Permit Type Building/Residential/Addition/SFD Permit Number B24000827 Opened Date 03/12/2024
 Description of Work SFD/ CONSTRUCT 26' X 18' 1-STORY ADDITION OVER CRAWL SPACE TO CREATE MASTER BEDROOM & BATHROOM SUITE, INSTALL BASEMENT ENTRYWAY, 1 STORY, Crawl Space, 3R, 1FB, 0HB, 0FP, OTHER STRUCTURE = None, 1BR, PORCH/DECK = N/A, ENERGY METHOD = UA Alternative,

SITE INSPECTION SHEET

PROPOSAL: 1 story living space addition over crawl space.

LOCATION DIAGRAM

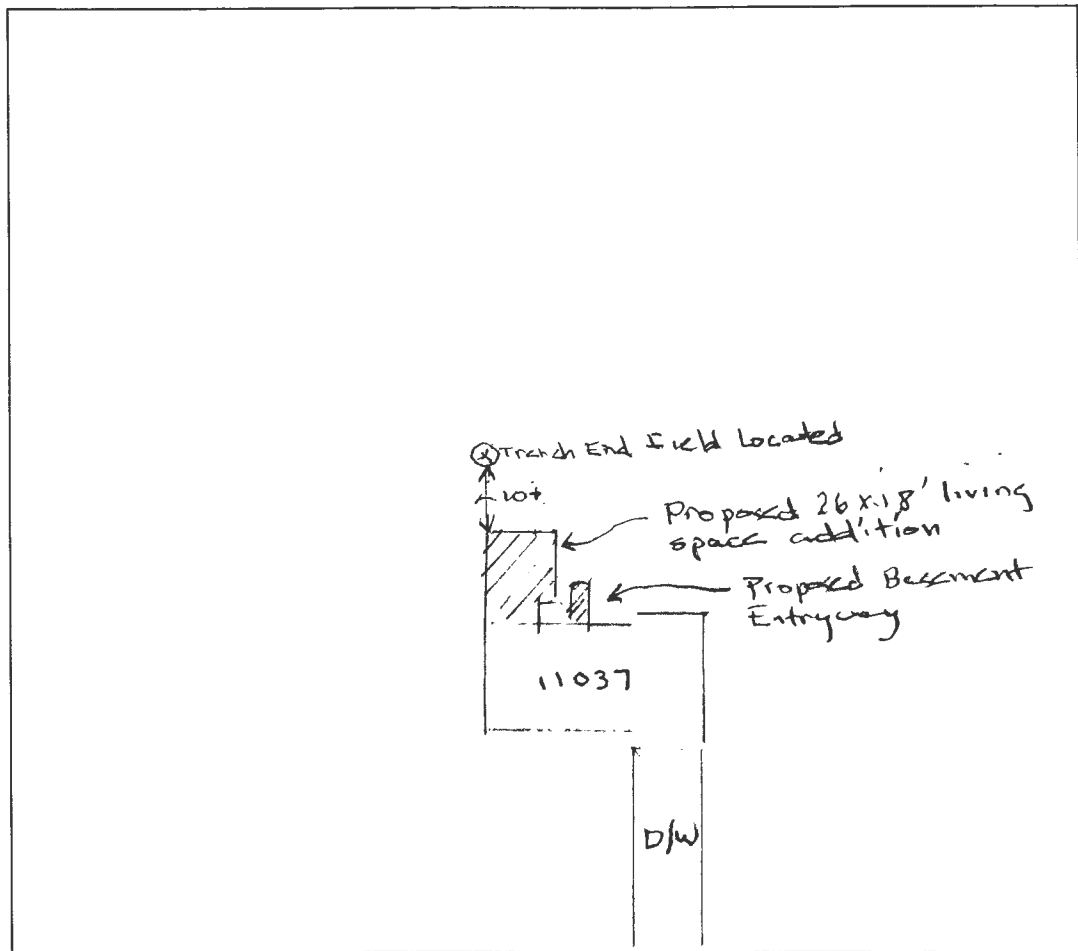
COMMENTS: Torsch Farm Road
Septic contractor field located trench end on 4/4/24.
Trench end was located ten plus feet away
from living space addition over crawl space.

FIRST FLOOR PLAN - OPT. #2

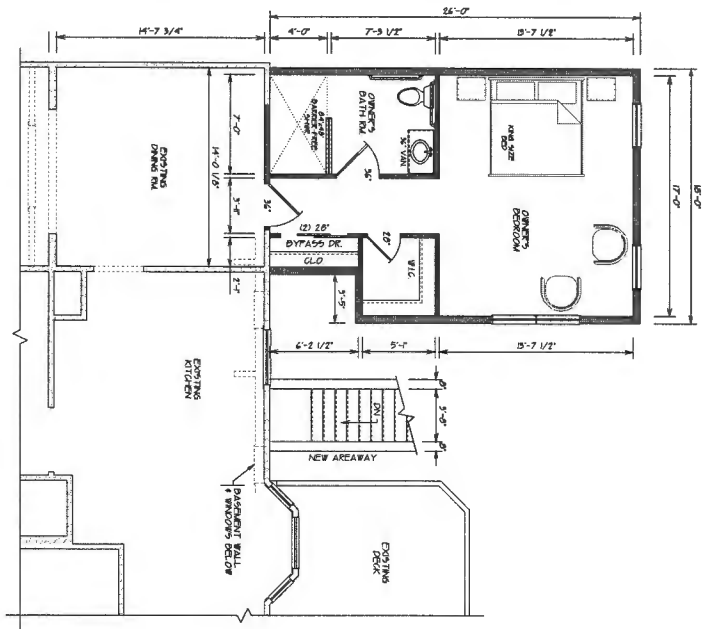
I do not have a site plan yet but I have attached the proposed addition. It is off of the rear left of the home, opposite side to where the septic tank is located and it extends 26' off the rear and is 18' wide. Homeowner would also like to put in a new basement entrance as shown.

One last thought since I have not seen a site plan for this proposal. Is the addition extending the footprint of the existing house? If so, in which direction? There are different setbacks between the septic tank and the SDA for a foundation addition. If the addition has a basement that is a different setback to the septic tank. Take a look at the records showing the SDA and the setbacks list attached. If they do not meet setbacks then the PC may need to be revised. If there is little encroachment into a setback a waiver may be able to be requested. Feel free to send me a site plan for a look see if its questionable.

Todd,
According to our records the closest existing trench to the rear left corner of the house looks to be 37ft. Since we are not adding a basement underneath the proposed addition the setback to the sewage disposal area (SDA) is 10ft. The existing trenches should be very close to the top edge of the SDA. When you are out on the property are there cleanouts/observation pipes installed at the ends of these trenches? I believe this can work without having to revise the PC since we have a general waiver for this kind of thing (see attached). I would still need to site plan showing all of this to be sure. The new entrance to the basement is not an issue setback wise but we would want to see any stormwater management devices being installed (if applicable). Only to make sure the outlet to the device would not be directed at the OSDS/SDA.
